PLAN COMMISSION STAFF REPORT

Agenda Item: PC Docket No. 22-023

Application: **Development Plan**

Summary: OKW Architects on behalf of Simborg Development requesting approval of development plan for 9,000 square feet of warehouse space, additional truck docks, new parking areas, and landscaping at the Lake Business Center Planned Unit Development at 9200 Calumet Avenue.

Figure 5 East elevation

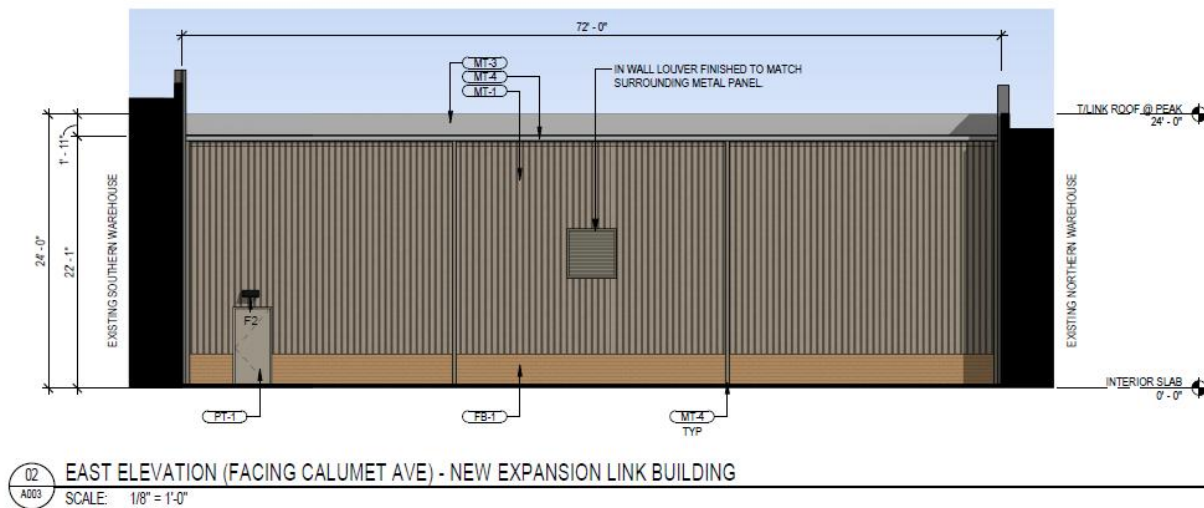
The materials for the east elevation facing Calumet Avenue are proposed to match the existing buildings in the development with a brick base: *HEBRON BRICK COMPANY "RED" | MODULAR | RUNNING BOND* and painted metal siding: *FIRESTONE UNA-CLAD | CHAMPAGNE | INSTALLED VERTICALLY WITH CONCEALED CLIPS*. The west (rear) elevation will be standard metal warehouse siding.

Figure 6 Area reserved for Maple Leaf Boulevard connection.

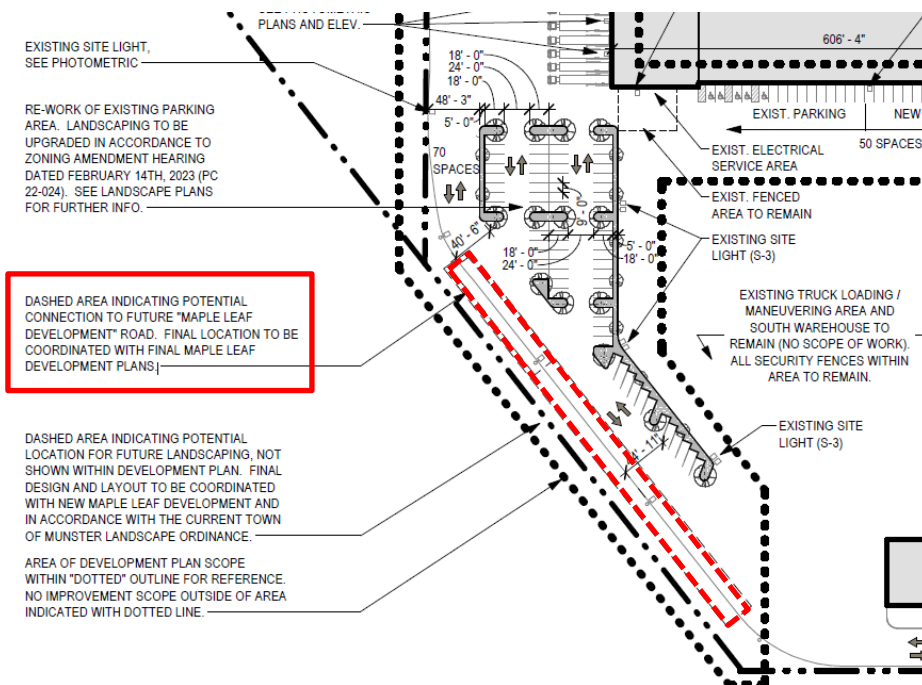
In keeping with the Town's intention to relocate truck traffic to the future Maple Leaf Boulevard, the applicant has proposed a connection to the proposed Maple Leaf Boulevard extension, which is shown on the west side of the property. The exact location is yet to be determined.

Figure 7 Location of new light fixtures

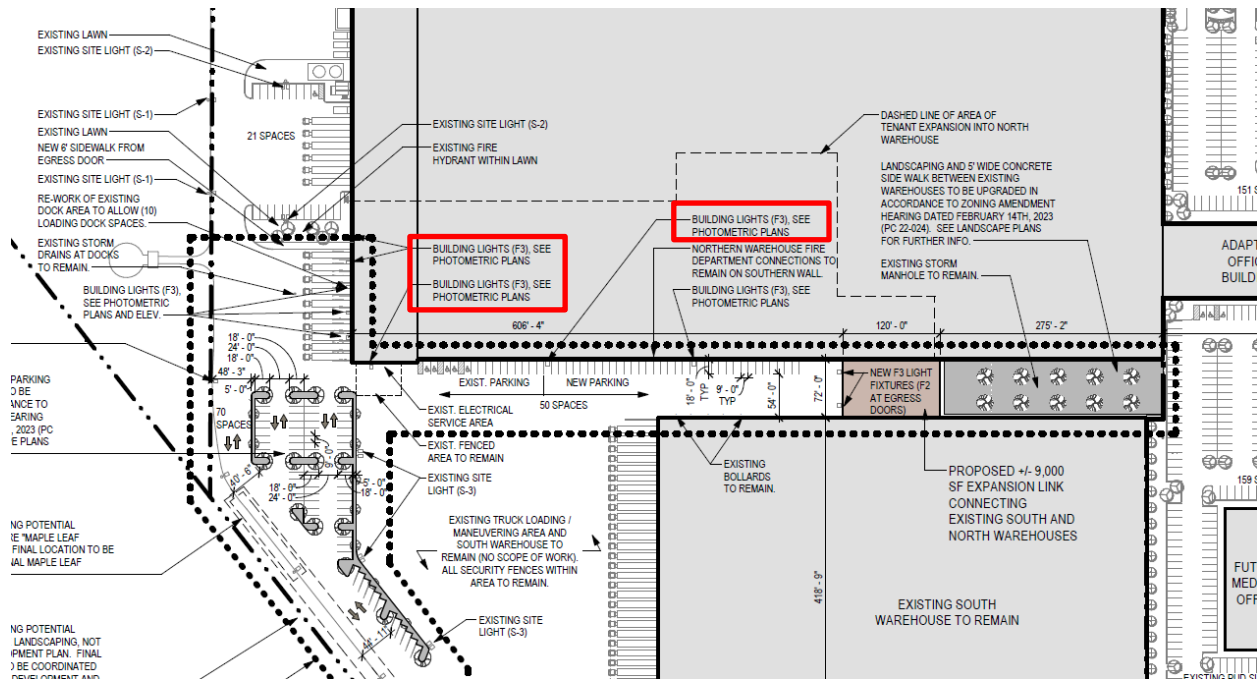
The development plan includes a lighting plan that includes a mixture of existing lights illuminating the existing parking lot on the southwest corner of the site and new lights to illuminate the new parking area between the warehouses and the new truck docks. The plan shows new light fixtures that do not meet the zoning standards for color temperature (less than or equal to 3000K). The applicant has not provided spec sheets of the fixtures, so it is unknown whether the fixtures are full cut-off as is required. The applicant has indicated that a revision to the plans is forthcoming, but staff did not receive it at the time that this memo was finalized.

Motion to approve PC Docket No. 22-023 to approve a development plan for 9,000 square feet of warehouse space, additional truck docks, new parking areas, and landscaping at the Lake Business Center Planned Unit Development at 9200 Calumet Avenue, contingent upon receipt of a compliant lighting plan and upon Town Council approval of the PUD amendment submitted under PC Docket 22-024.
